Chapter 2 – Project Refinement

AAP01-000-GEG-GGEN-00002

2 Project Refinement

Figure 2-1: Powell Creek Ancillary Infrastructure

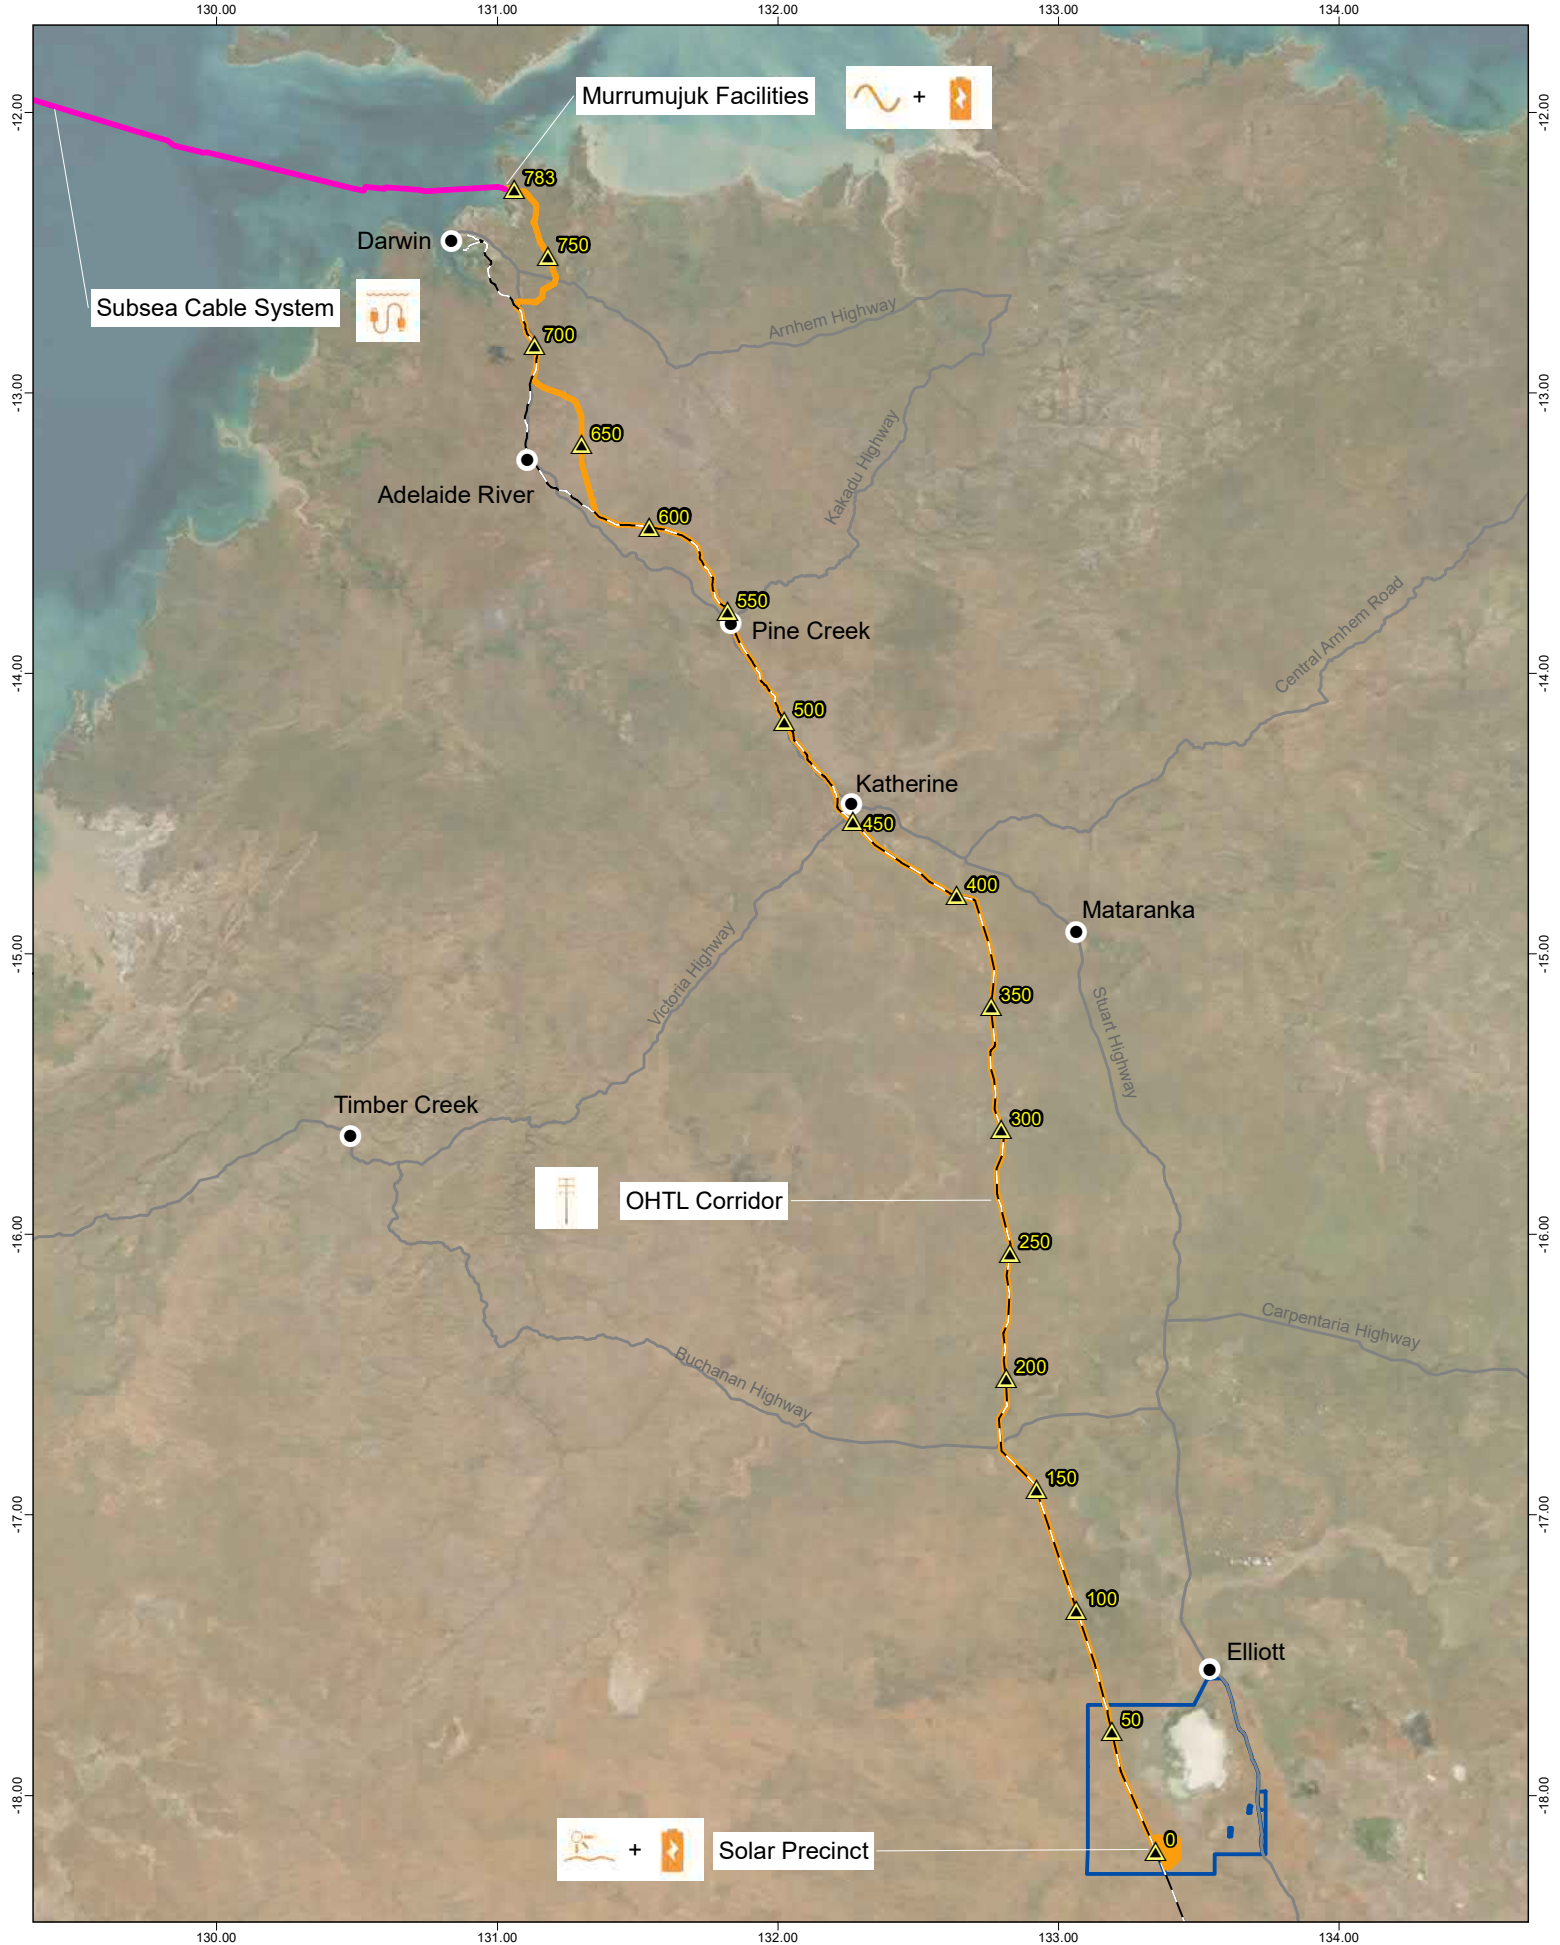
Section 2.4 lists borrow pits (outside the Solar Precinct) will be required for construction. Section 2.4.4.5 indicates 1.5 million cubic metres of crushed rock will be extracted. Figure 2-15 shows an indicative borrow adjacent to the Stuart Highway.

Section 2.2.3 includes additional detail requested for the Borrow Pit sizing and the location is included in Figure 2-5.
